May 15, 2023
Revised August 19, 2023

Re: Engineering Services
Tucker Residence
111 4th Street, Erwin NC
10.000 kW System

Project Information:

TSP157581 Adrian Tucker

DATE: 8/17/2023
SHEET NAME SITE PLAN
SHEET SIZE ANSI B 11" X 17"
SHEET NUMBER PV-2

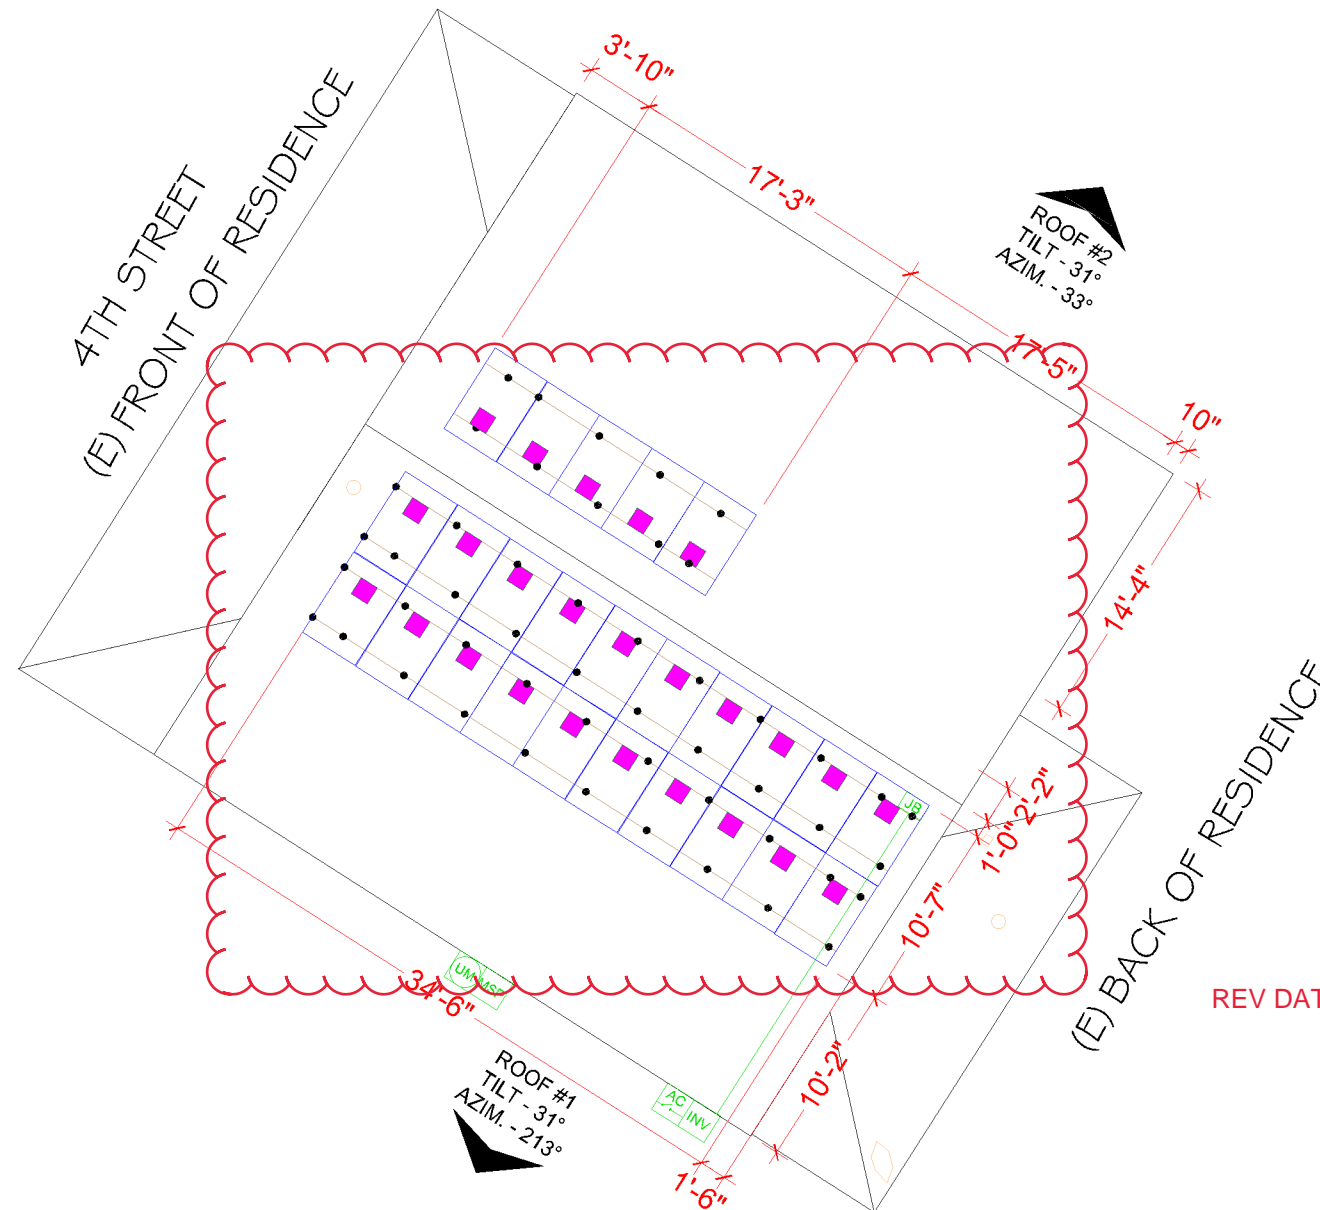
- We have revised layout as per the image attached. 20 modules in roof 1 and 5 modules in roof 2.

No Further Changes.
